PLANT NAME: Oconee

ENCLOSURES:
Request for change to tech specs.....consist of Title changes within the station organization....and Changes to the Station organization chart, Fig. 6.1-1

Re: Oconee Nuclear Station
Docket Nos. 50-269, -270, -287

Section 6.1.1 of the Oconee Nuclear Station Technical Specifications, Appendix A to Facility Operating Licenses DPR-38, -47, and -55, specifies the organization of Oconee Nuclear Station. Pursuant to 10CFR50.59, it is requested that the Oconee Nuclear Station Technical Specifications be revised to show:

OCONEE NUCLEAR STATION
STATION ORGANIZATION CHART
FIGURE 6.1-1

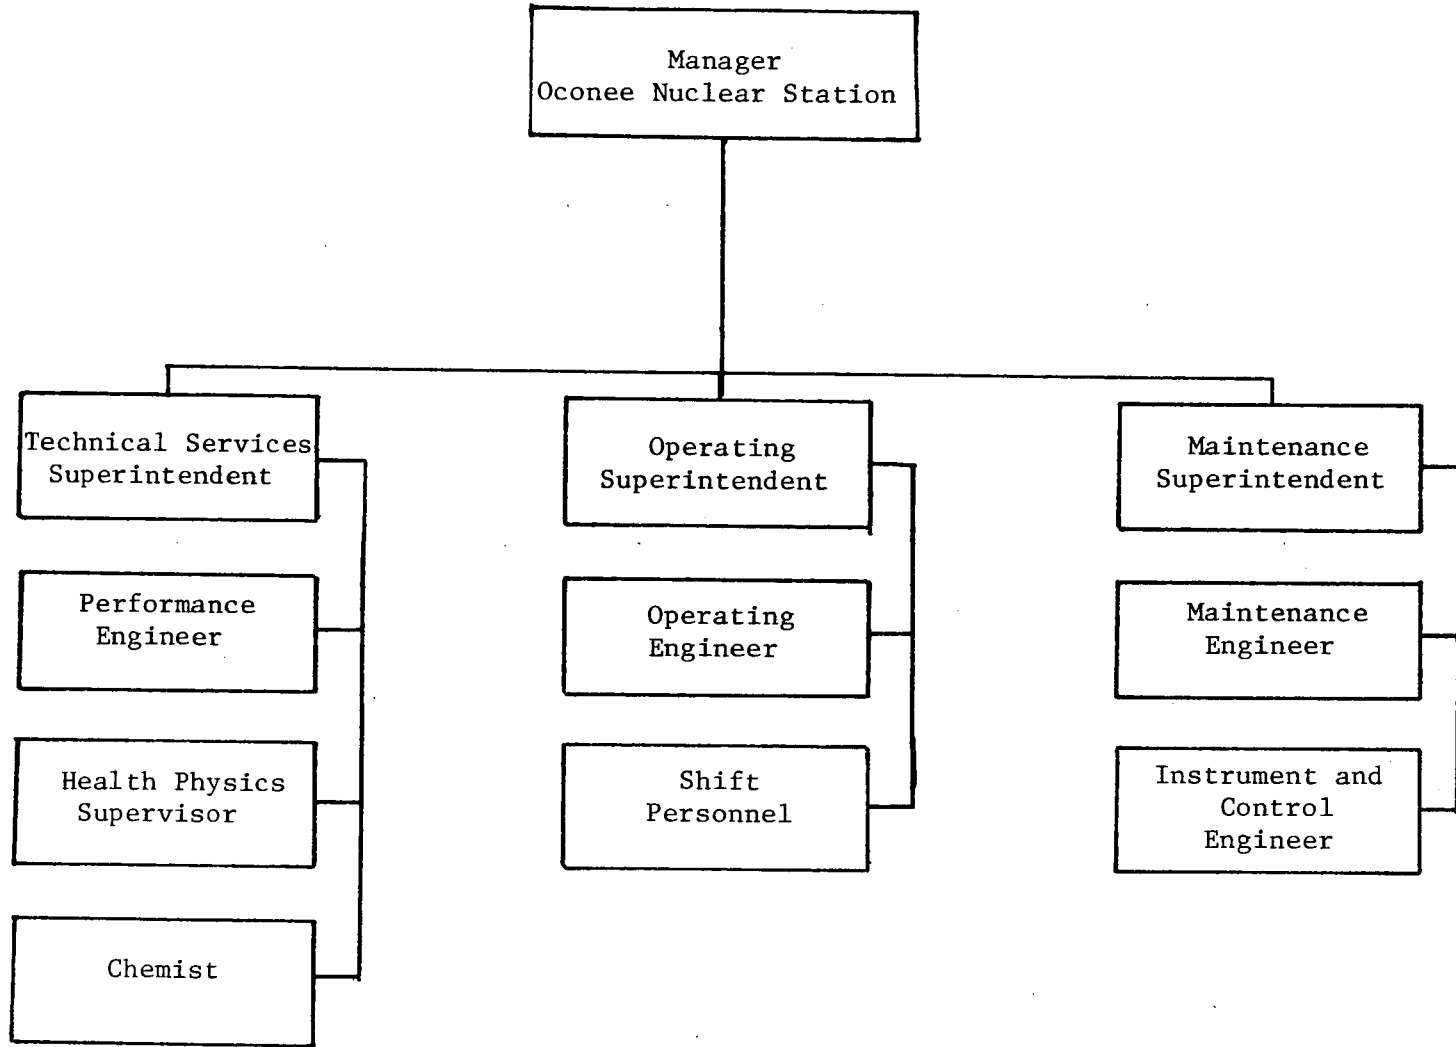
1. Title changes within the station organization such as Superintendent to Manager, Technical Support to Technical Services, etc.
2. Changes to the station organization chart, Figure 6.1-1.

6.1.1.3 The station organization for Operations, Technical Services, and Maintenance shall be functionally as shown in Figure 6.1-1. Minimum operating shift requirements are specified in Table 6.1-1.
